# SUBDIVISION REPORT - CONCEPT/USE ON REVIEW

► **FILE #:** 9-SB-21-C **AGENDA ITEM #:** 21  
 9-C-21-UR **AGENDA DATE:** 9/9/2021

► **SUBDIVISION:** HOPPE SUBDIVISION  
 ► **APPLICANT/DEVELOPER:** HOMESTEAD LAND HOLDINGS, LLC  
 OWNER(S): C W Hoppe, Jr. & Julia G. Hoppe

**9-SB-21-C / 9-C-21-UR  
CONCEPT PLAN/USE ON REVIEW**

CONCEPT OF HOPPE PROPERTY  
KNOX COUNTY, TN  
OVERALL LAYOUT  
(9-SB-21-C / 9-C-21-UR)

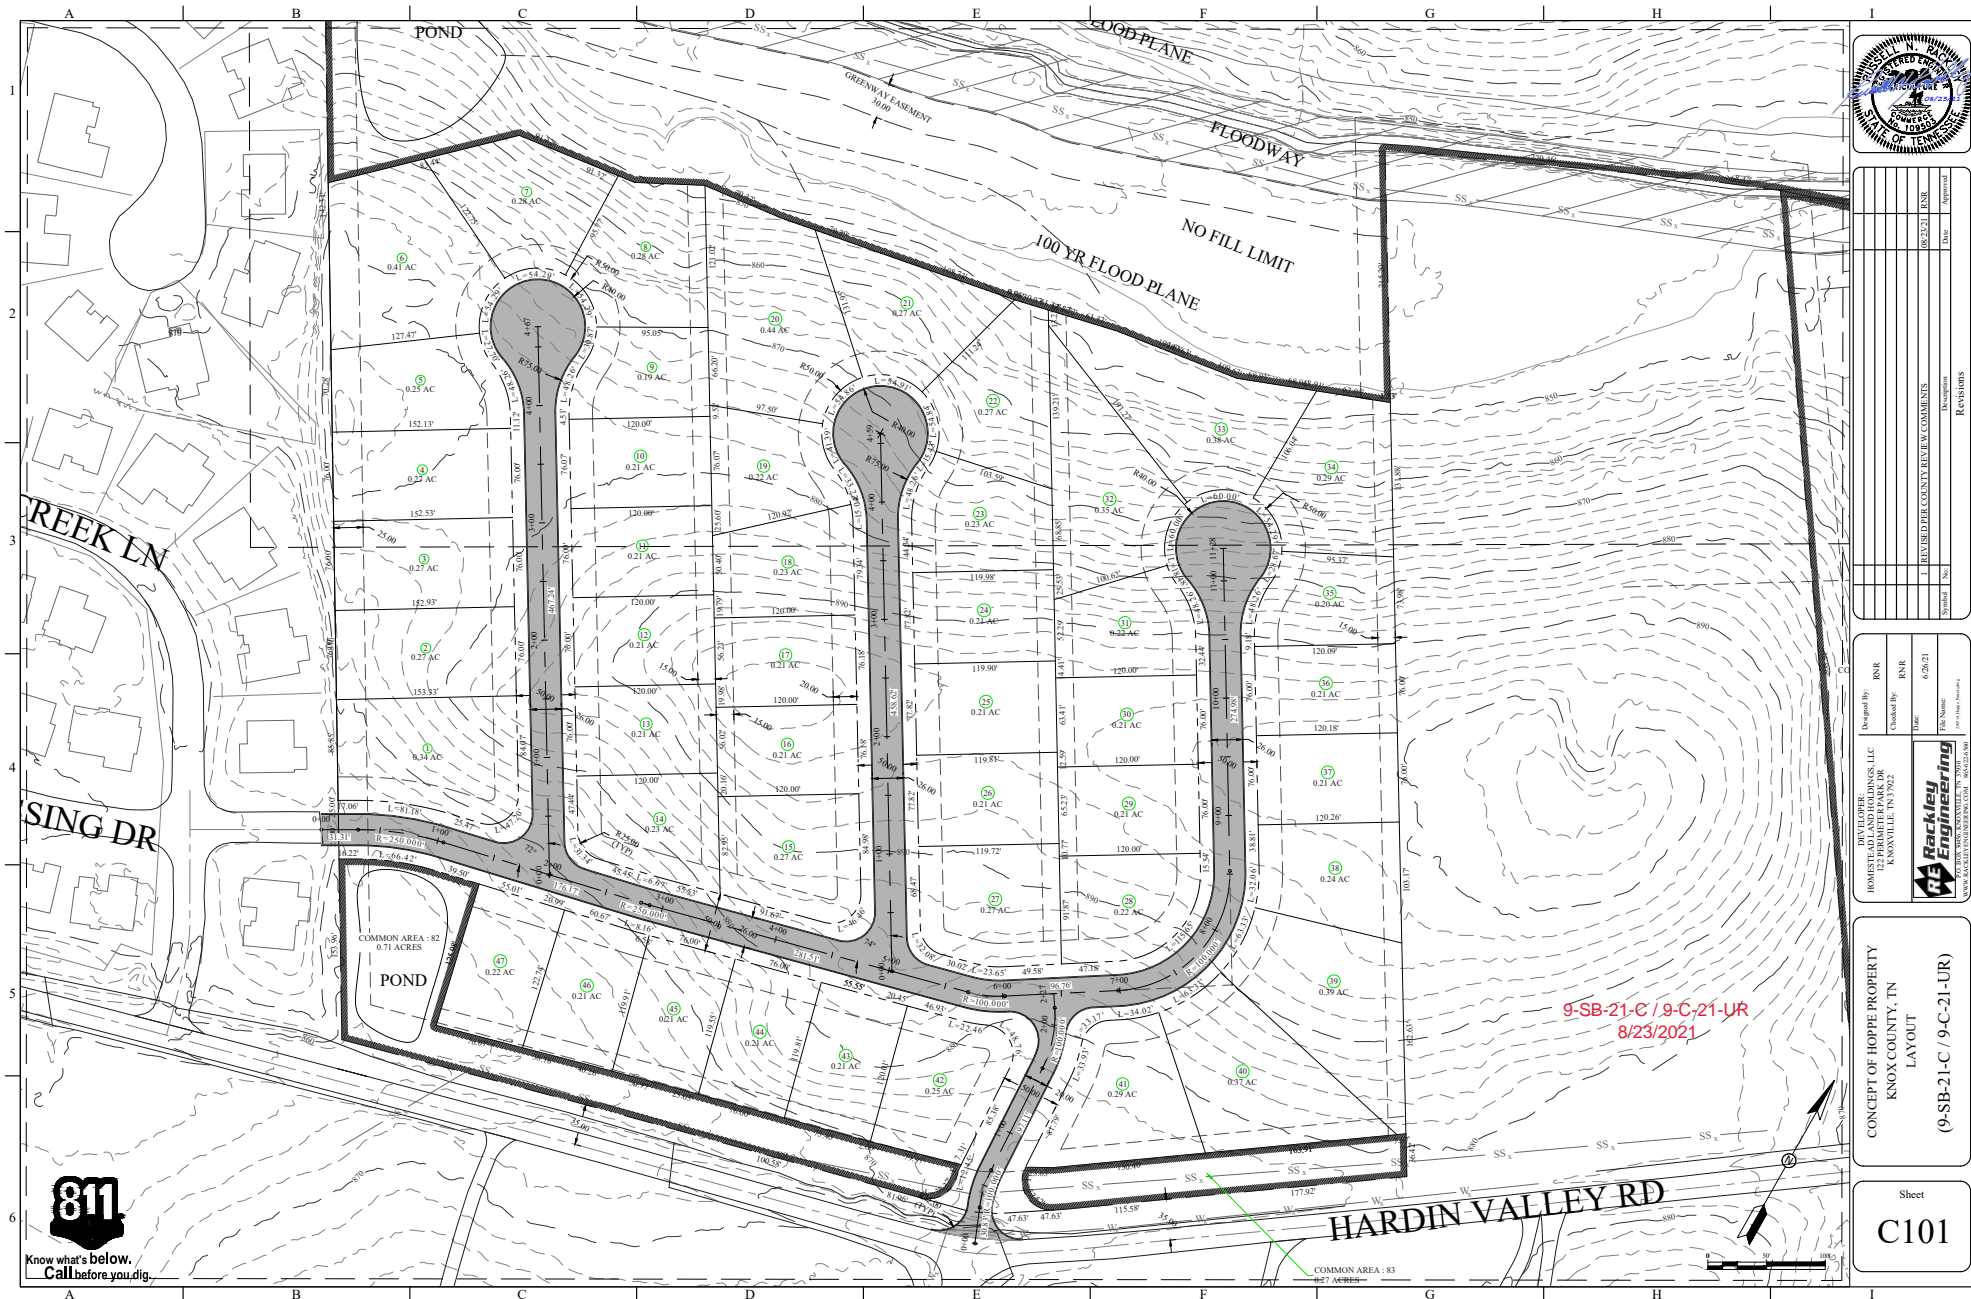
► **SUBDIVISION VARIANCES REQUIRED:** VARIANCES:

1. REDUCE THE MINIMUM TANGENT BETWEEN BROKEN BACK CURVES FROM 150' TO 96.76' ON ROAD 1 FROM STA 6+00 TO STA 7+00.
2. REDUCE THE MINIMUM ANGLE OF INTERSECTION FROM 75 DEGREES TO 71 DEGREES AT THE ROAD 2 INTERSECTION WITH ROAD 1.
3. REDUCE THE MINIMUM ANGLE OF INTERSECTION FROM 75 DEGREES TO 74 DEGREES AT THE ROAD 3 INTERSECTION WITH

1. REDUCE THE MINIMUM HORIZONTAL RADIUS FROM 250' TO 100' ON ROAD 1 (TWO LOCATIONS).
2. REDUCE THE MINIMUM PAVEMENT WIDTH ON ROAD 4 FROM 26' TO 20'.

- **Approve the development plan for up to 47 detached and 33 attached residential dwellings on individual lots and the peripheral setback reduction from 35-ft to 25-ft, subject to 1 condition.**

Applicant is requesting a 15-ft peripheral setback for the eastern boundary lines of Lots 34-39.

The applicant is requesting a reduction of the peripheral setback from 35-ft to 25-ft for the boundary of the entire development with the exception of lots 34-39 where the request is for a 15-ft peripheral setback. Staff is recommending approval of the 25-ft peripheral setback for the entire development, excluding the 15-ft request, for the following reasons:

- 1) Along the Hardin Valley Road frontage, a 25-ft common area is being provided which creates a rear lot property line for the lots that adjoin it. From the rear lot line, the houses will have an additional 15-ft setback for a total setback of 40-ft from the Hardin Valley Road right-of-way, which is greater than the standard 35-ft peripheral setback. By reducing the peripheral setback to match the common area width, the adjoining lots will not have two different setbacks in the rear yard; 10-ft of the 35-ft peripheral setback and the 15-ft rear setback.

- 2) The Planning Commission approved a peripheral setback reduction to 25-ft for the adjacent subdivisions to the west and north and this request will be consistent with the surrounding development.

- 3) The requested 15-ft peripheral setback for lots 34-39 is not consistent with the proposed 35-ft peripheral setback on the adjacent Mission Hills subdivision, which is also being considered for concept plan and use-on-review approval on this agenda (7-SA-21-C / 7-C-21-UR). A 25-ft peripheral setback is consistent with the rest of the subdivision and other surrounding subdivisions.

- **Approve variance 1-3 and alternative design standards 1-2 on the recommendations of the Knox County Department of Engineering and Public Works and because the site conditions restrict compliance with the Subdivision Regulations and the proposed variances and alternative design standards will not create a traffic hazard.**

CONCEPT OF HOPPE PROPERTY  
KNOX COUNTY, TN  
CONCEPT GRADING  
(9-SB-21-C / 9-C-21-UR)

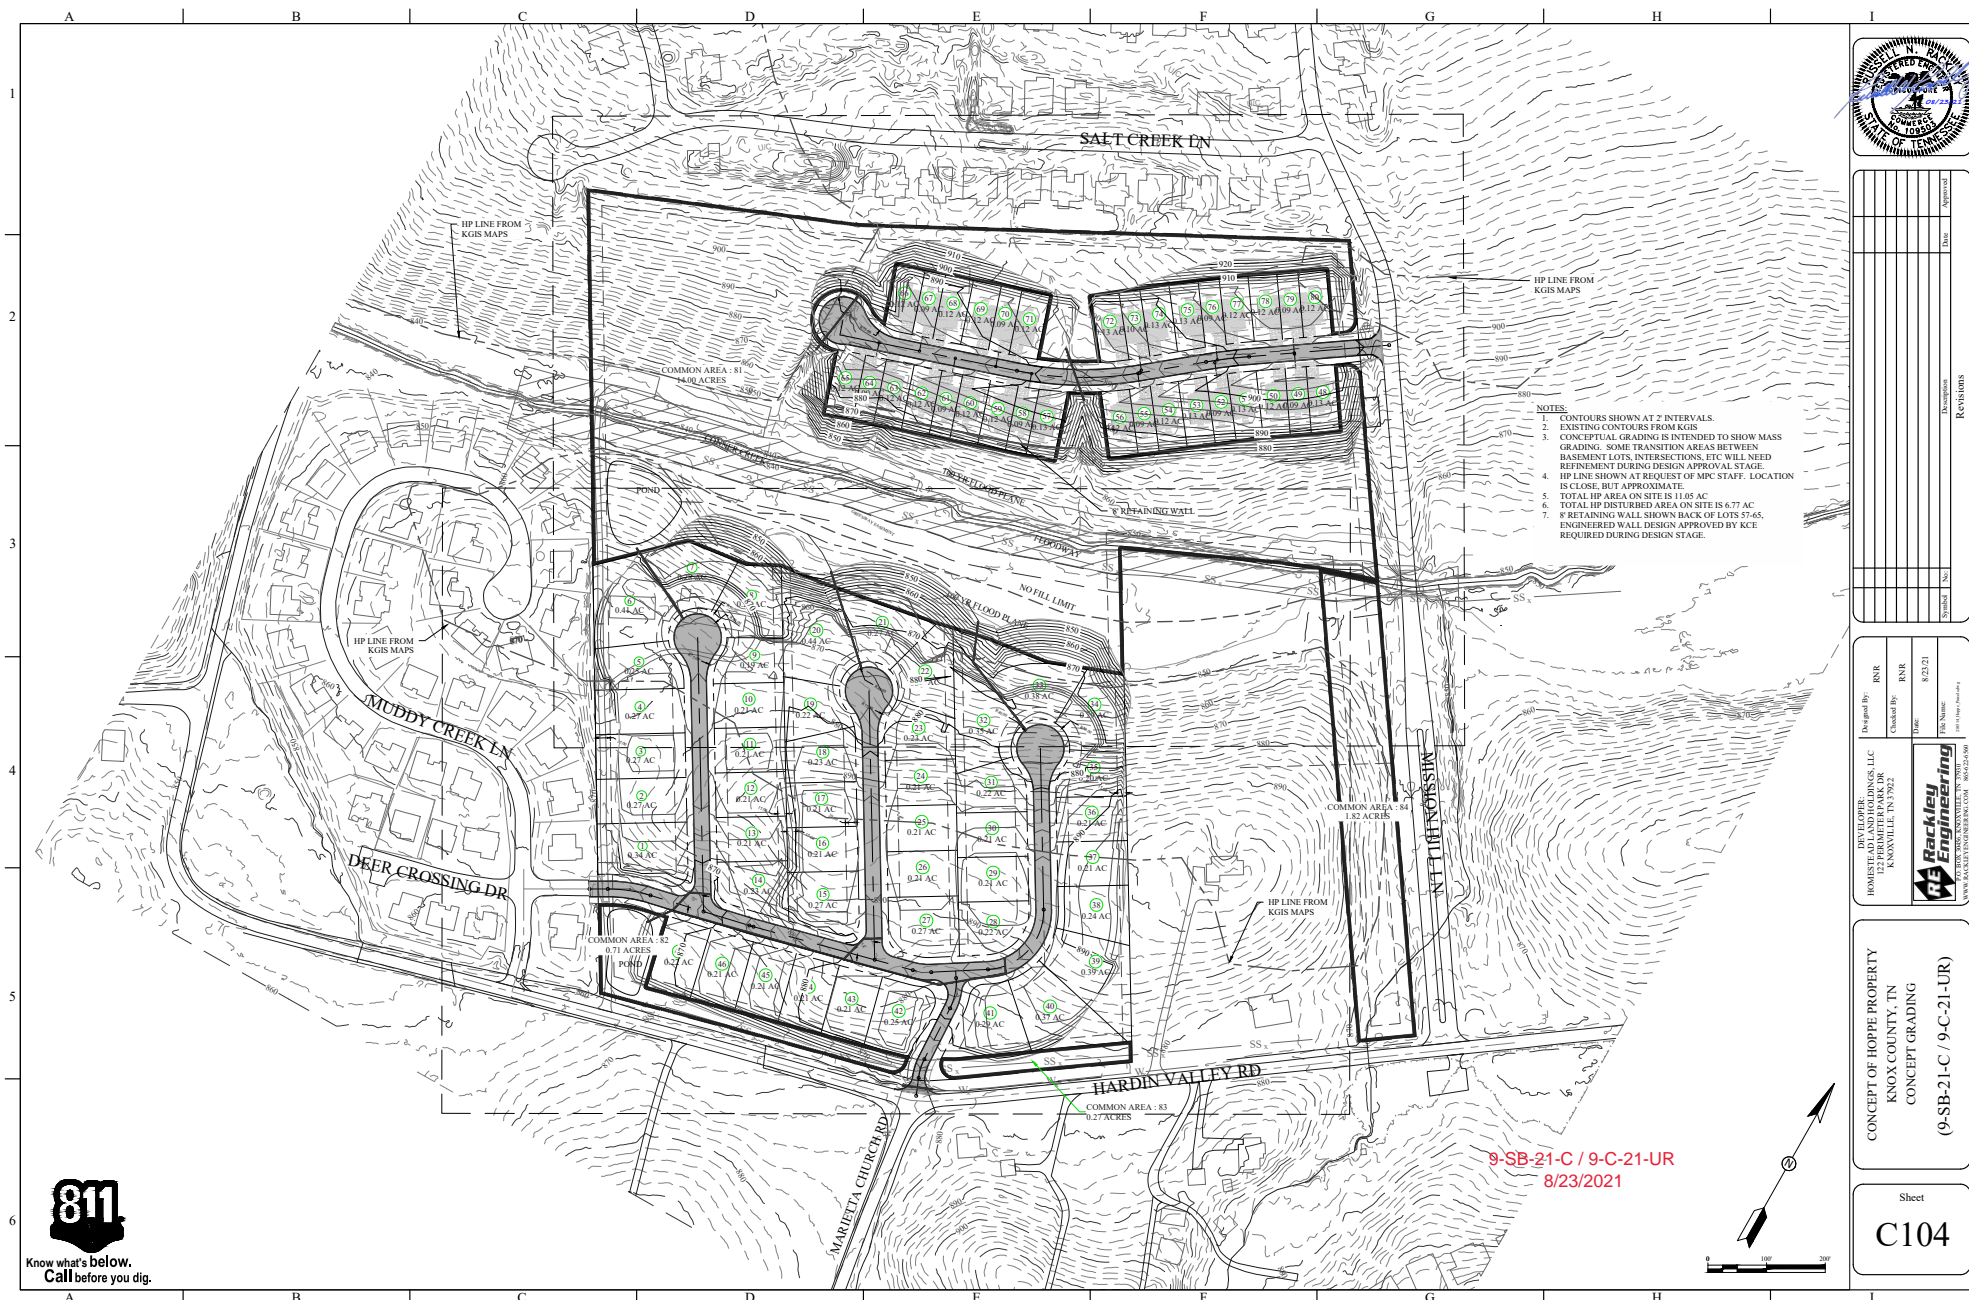
(see the attached slope analysis). The recommended maximum land disturbance within the HP area is 7.2 acres and according to the applicant, 6.8 acres of the HP area will be disturbed (sheet C104).

C. Approximately 11 acres of the 36.77-acre site is within the Hillside Protection (HP) area and the recommended maximum disturbance according to the slope analysis is 7.2 acres. The proposed disturbance within the HP area is 6.8 acres.
